## **CITY OF MILLERSBURG PLANNING COMMISSION MEETING**

- 1) File No: DC 18-01 Pratum Expansion

File No: SP 20-01 RENA ADDITIONAL SIGN

# Zoning Map SP 20-02

<b>SITE PLAN</b>	
NOLAN SHROCK - PRATUM 3653 NE STEELHEAD RUN ALBANY, OREGON	
Job No. 20-106NS	Date: JUNE 2020

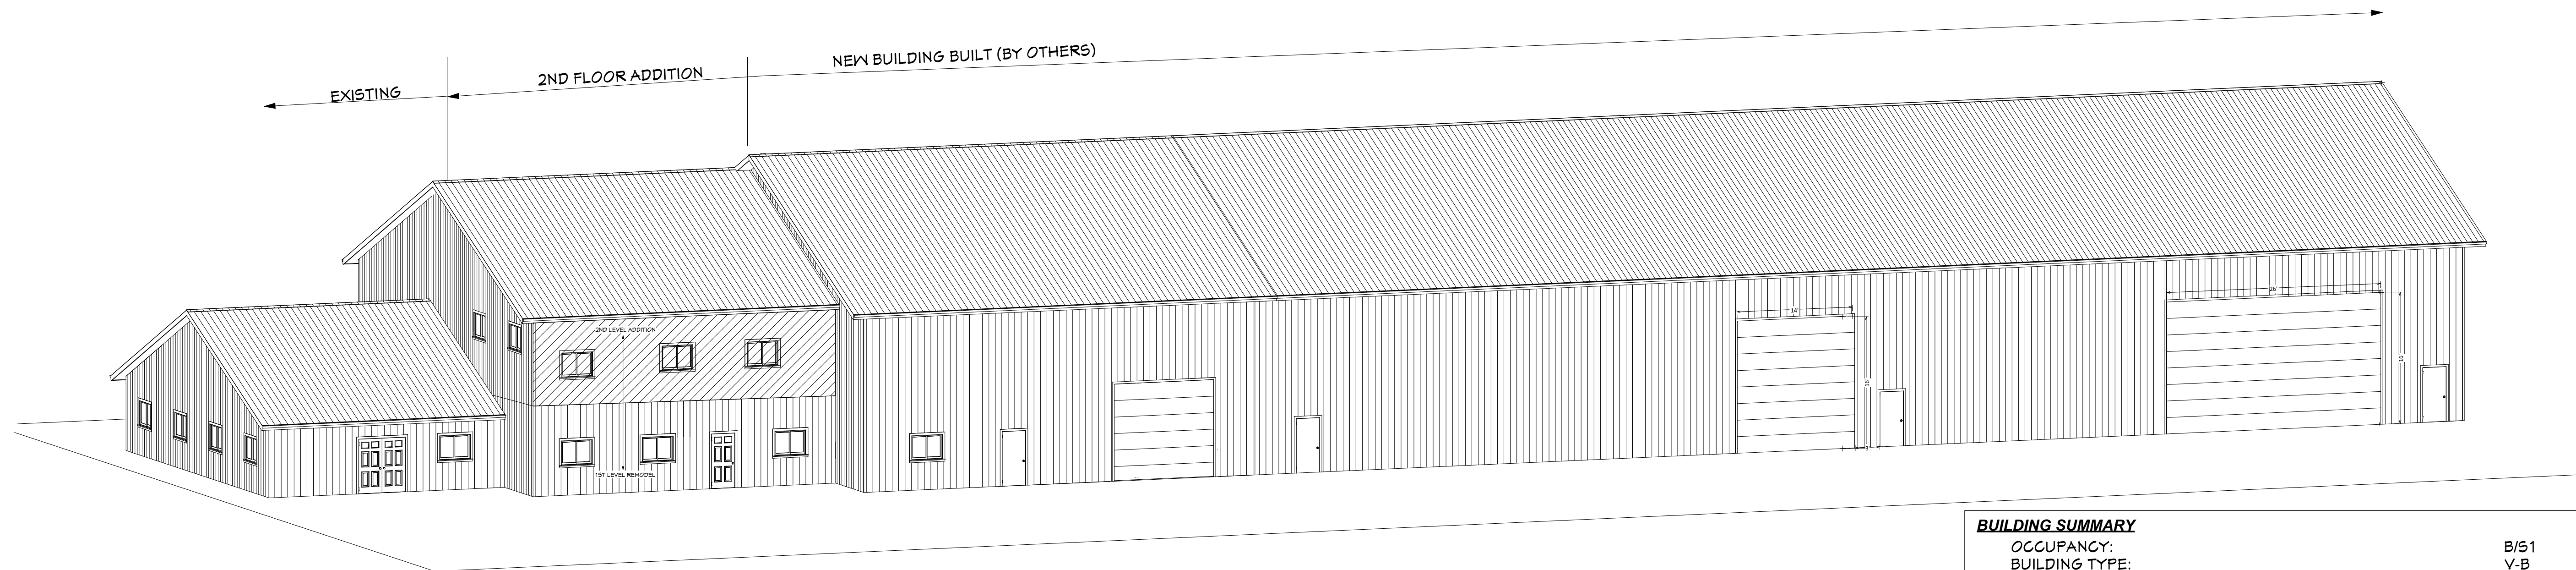
**ANALYSIS:** The proposed project includes an expansion of the parking area. The proposed expansion is to be paved based on the site plan submitted by the applicant.

**ANALYSIS:** A site plan was included that shows all new and existing parking.

**ANALYSIS:** While some landscaping is shown on the site plan with labels indicating landscaped areas, the parking landscaping is not clear. As such, a condition of

The project requires a total of 27 parking spaces. The site plan shows a total of 27 spaces.

**ANALYSIS:** The proposed new parking areas do not meet this standard in that there are no landscape islands at the end of the parking rows, and the plans do not show that at least 5% of the parking area is landscaped. A condition of approval has been added to require the site plan to be revised to show the required islands, landscape plans to show the landscaping, and to have the

landscaping and island constructed, with irrigation, prior to the final inspection of the building. The applicant has indicated that the islands could present safety concerns and has requested not to build them. The code does not have a provision to allow the Planning Commission to consider alternatives on this issue, and the staff feel that the islands would not present safety risks if properly located and landscaped.

approval has been added to the project requiring a full landscape plan to be submitted showing all site landscaping in detail, including plant density, species, irrigation and sizes.

4. The applicant shall provide landscape plans that show all landscaped areas on the project site, including parking lot areas and streetscapes. The plans shall include details on plant types, plant densities, tree types and species, planting details, and full irrigation plans. The plans must specifically show:
  - Parking lot landscaping that includes at least 5% of the parking area in landscaping; and,
  - At least one landscaped parking island at the end of each parking row; and,
  - Street trees at least 30 feet apart for the full street frontage of the entire project site.
5. The applicant shall submit a revised site plan for staff approval that includes:
  - A landscaped island in the parking area at the end of each row of parking stalls.
